## New Model Introduction

New model GR-6300-000 is offered as a direct replacement for model GC30916A. Models have common mounting and tooling and are dimensionally the same.

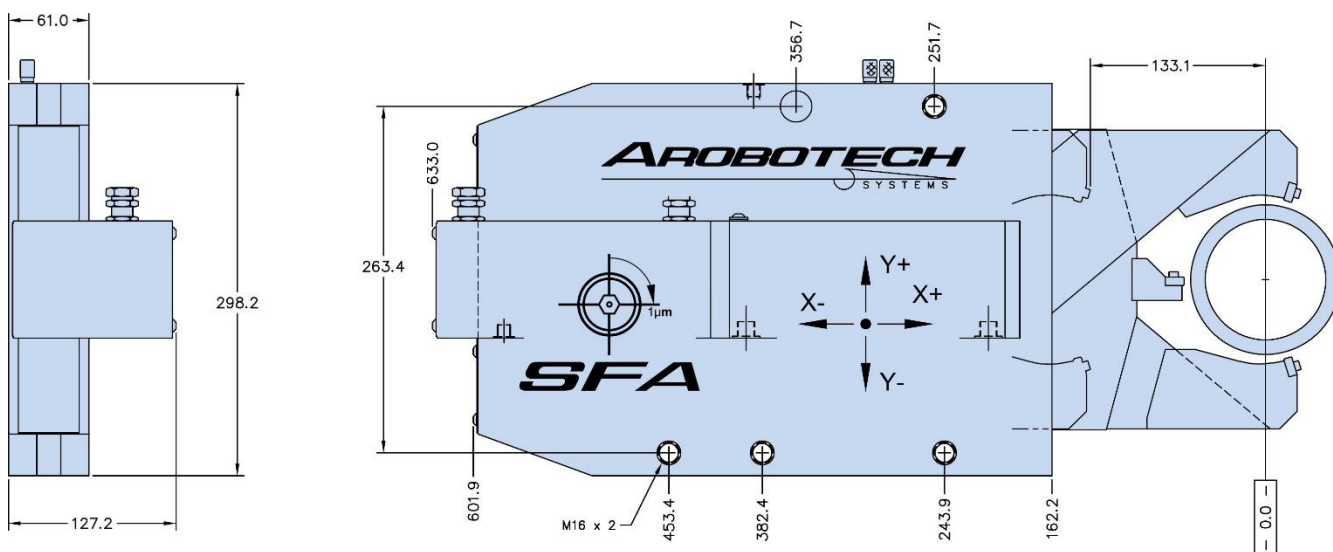
### Gen 4 Model GC30916A (V048653)

- \* Max Clamp Size = 140mm Diameter
- \* 20.3 cm<sup>2</sup> Piston Area
- \* X-Axis = 3.1° Turn = 0.001mm Adjustment ▪ ±0.22mm Total Adjustment
- \* Y-Axis = 10.4° Turn = 0.001mm Adjustment ▪ ±0.07mm Total Adjustment

### Gen 5 Model GR-6300-000 (V110584)

- \* Max Clamp Size = 140mm Diameter
- \* 20.3 cm<sup>2</sup> Piston Area
- \* 90° Turn = 0.001mm Adjustment (both axis)
- \* +/- 0.200mm Total Adjustment (both axis)
